# UNITED STATES PATENT AND TRADEMARK OFFICE

APPLICATION NO.	FILING DATE	FIRST NAMED INVENTOR	ATTORNEY DOCKET NO.	CONFIRMATION NO.
10/737,265	12/15/2003	Jean-Pierre Steiner	P/3328-63	5796

**Office Action Summary**

## **DETAILED ACTION**

Hayes et al., 5,620,291

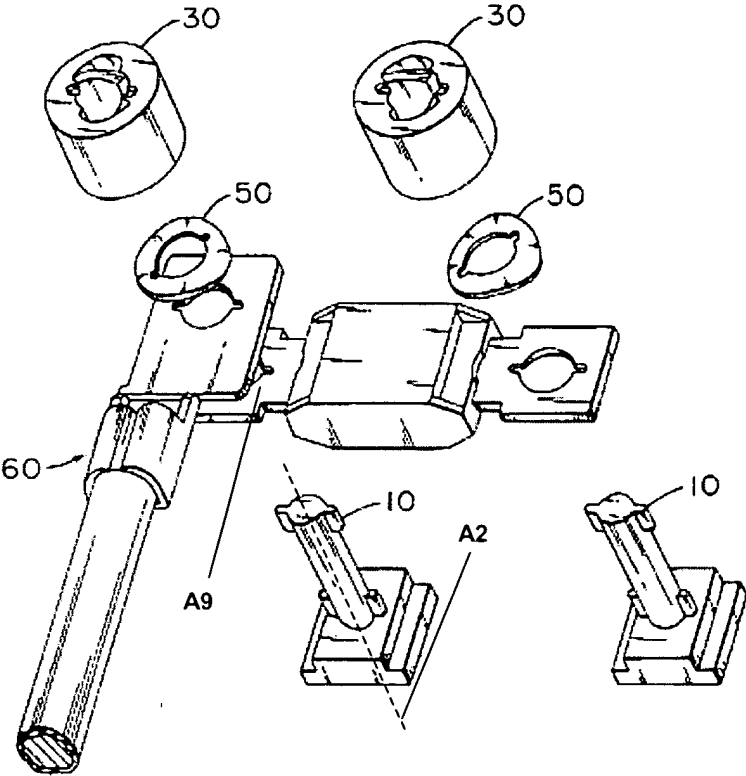
Regarding claim 1, as best understood, Hayes discloses, in Figure 6, an assembly member comprising a first flat tool **30**, a second flat tool **A9**, and a cylindrical unit **14** having a rotating axis **A2**. The cylindrical unit **14** includes elements **22,25**.

Regarding claim 8, a gripping profile **12** is at least at one end **16** of the cylindrical unit **14** and shaped to facilitate revolution of the cylindrical unit **14** around the rotating axis **A2**.

Regarding claim 9, the gripping profile **12** includes a profile defined inside the cylindrical unit **14** or a profile defined on the outside of the cylindrical unit **14**.

Regarding claim 10, at one end **16** of the assembly is a head and the gripping profile **12** is defined at the head.
